LINCOLN CITY/LANCASTER COUNTY PLANNING STAFF REPORT

P.A.S.: PP #01017 - Cardinal Heights 1st Addition **DATE:** January 24, 2002
SP #1940 - Cardinal Heights Community Unit Plan

PROPOSAL: Preliminary Plat 209 lots and 2 outlots for 189 single family, 18 townhouse and 2 single family attached dwelling units.

COMMUNITY UNIT PLAN/ SPECIAL PERMIT

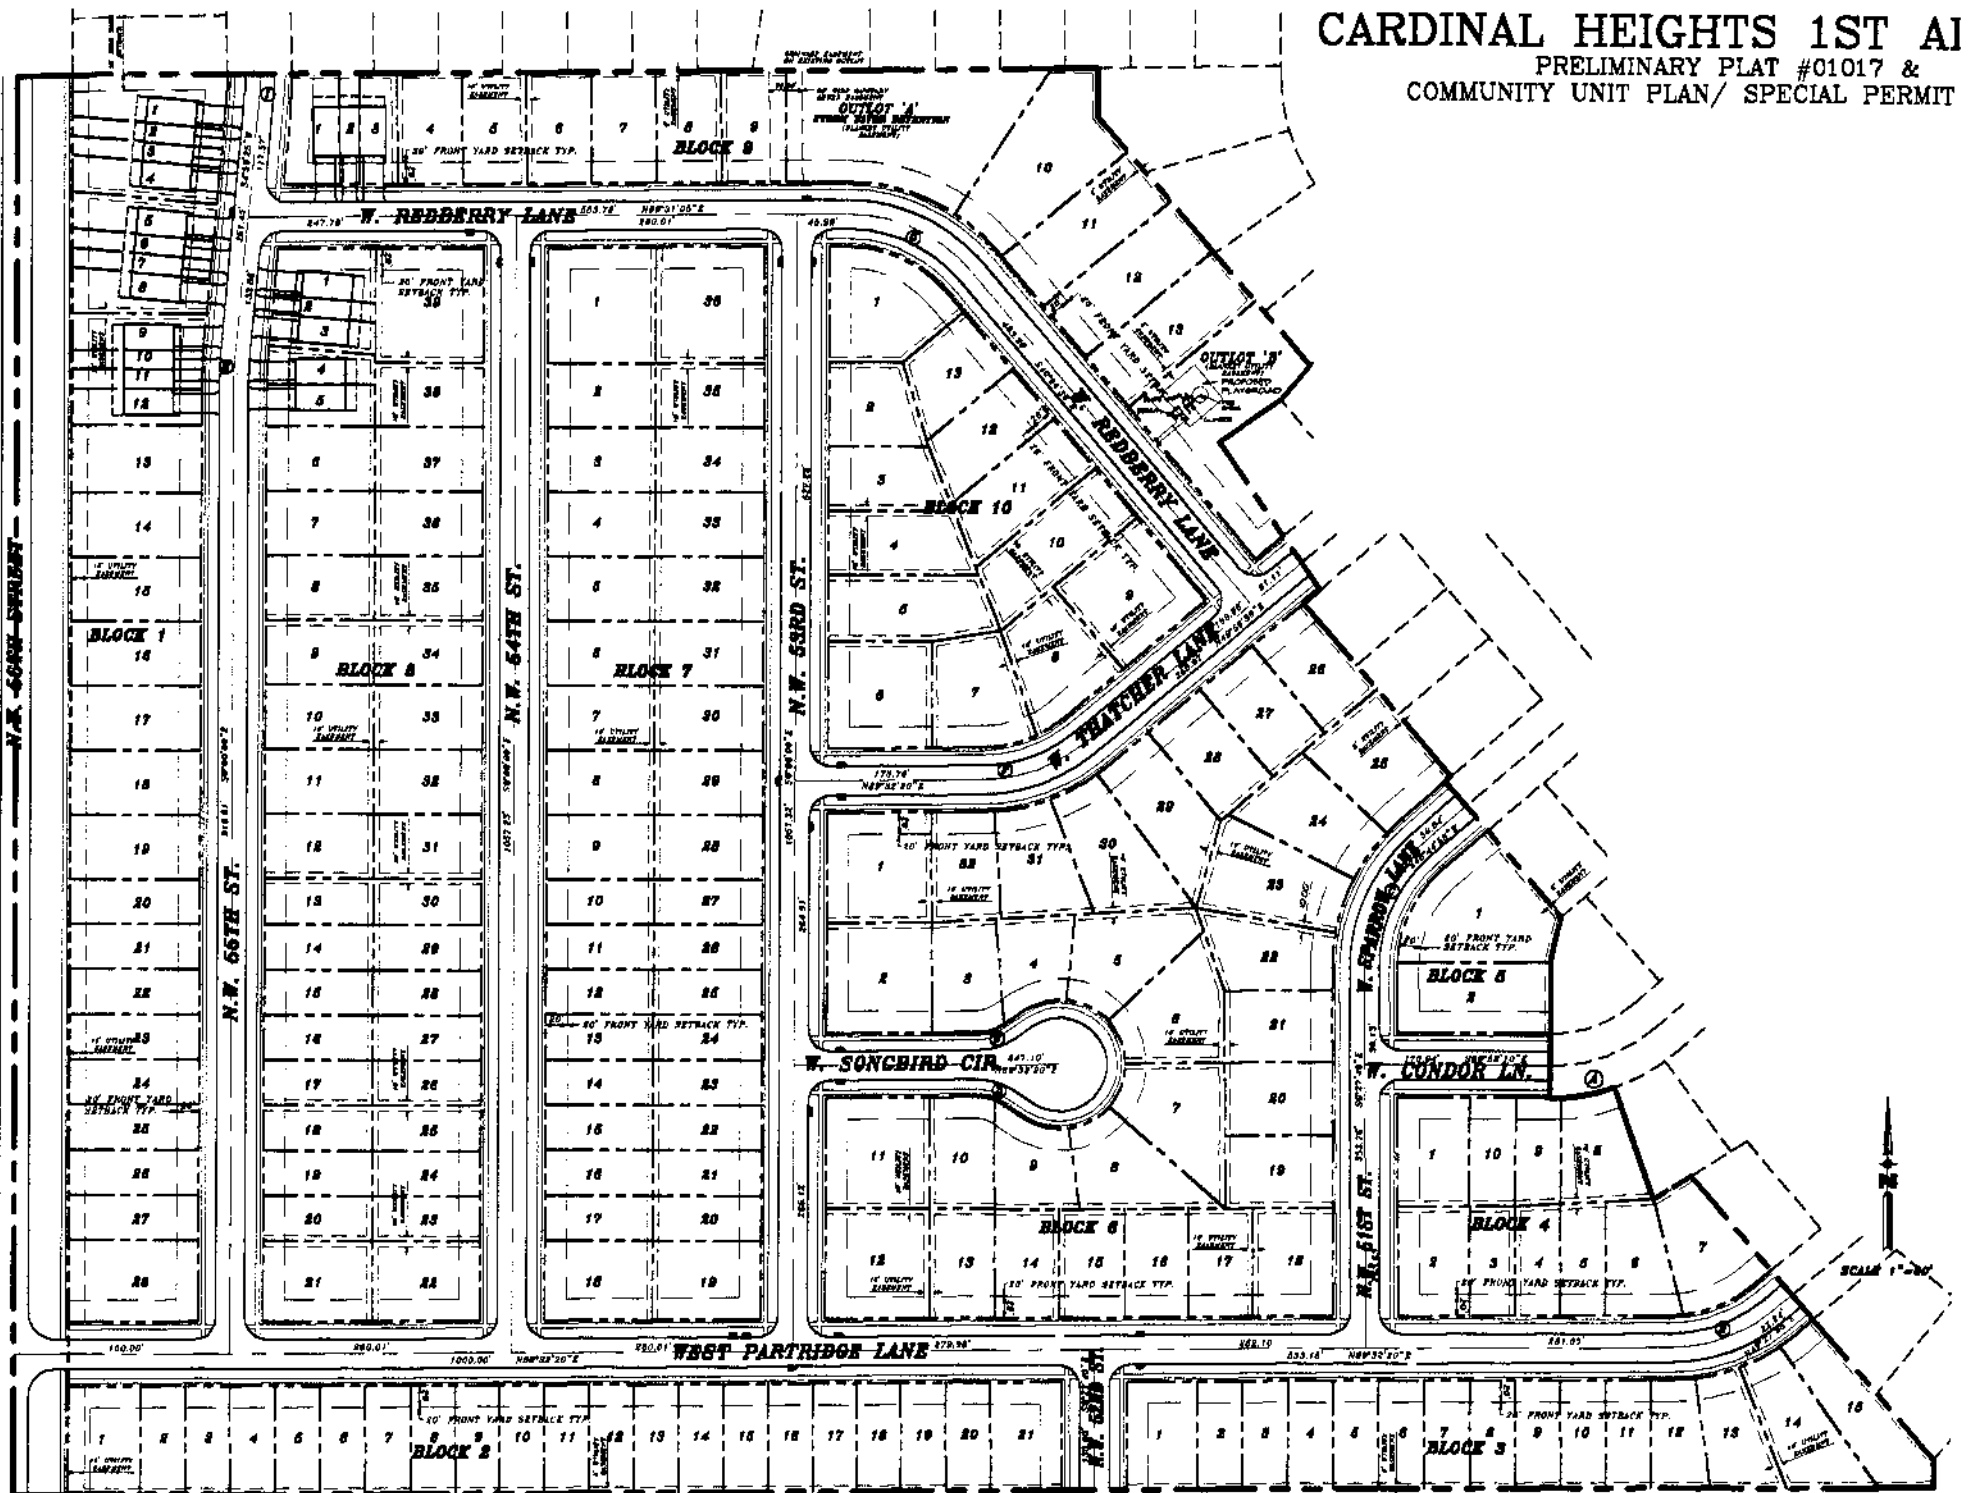
1. This is an application for a preliminary plat for 209 lots and two outlots and a special permit for a community unit plan for 209 dwelling units consisting of 189 single family, 18 townhouse, and 2 single family attached lots with a modification to allow 42-foot wide lots, waive the lot width to depth ratio on 17 lots, and reduce the rear yard setback on lots as shown on the site plan.

6. The Public Works & Utilities Department noted that the phasing plan is unclear and needs to be revised to clearly indicate which phases will not be platted until N.W. 56th Street is paved and the sewer improvements are installed in N.W. 48th Street.

7. The Public Works & Utilities Department indicated that an easement shows the ability to build and maintain the portions of the storm water detention facility outside the limits of this plat in Outlot D, Olympic Heights Addition. The grading plan needs to be revised to show grading to the north of this plat. The calculated 100 year storage floods a portion of existing platted lots. The flood pool must remain in the outlot, currently the grading plan shows grading on private lots outside Outlot D.

1. After the subdivider completes the following instructions and submits the documents and plans to the Planning Department office, the preliminary plat will be scheduled on the City Council's agenda: (NOTE: These documents and plans are required by ordinance or design standards.)
 - 1.1 Revise the preliminary plat to:
 - 1.1.1 Indicate easements required by the December 10, 2001 Lincoln Electric System memo.
 - 1.1.2 Revise Note #1 of the General Notes to indicate "189 single family, 18 townhouse, and 2 single family attached".

- 1.1.8 Indicate the purpose of the 50' of additional right-of-way to be dedicated at the time of final platting.
 - 1.1.9 Add a 12" water main in N.W. 56th Street to the satisfaction of the Public Works & Utilities Department.

- 1.1.10 Revise the grading plan to the satisfaction of the Public Works & Utilities Department.
 - 1.1.11 Revise the phasing plan to the satisfaction of the Public Works & Utilities Department.
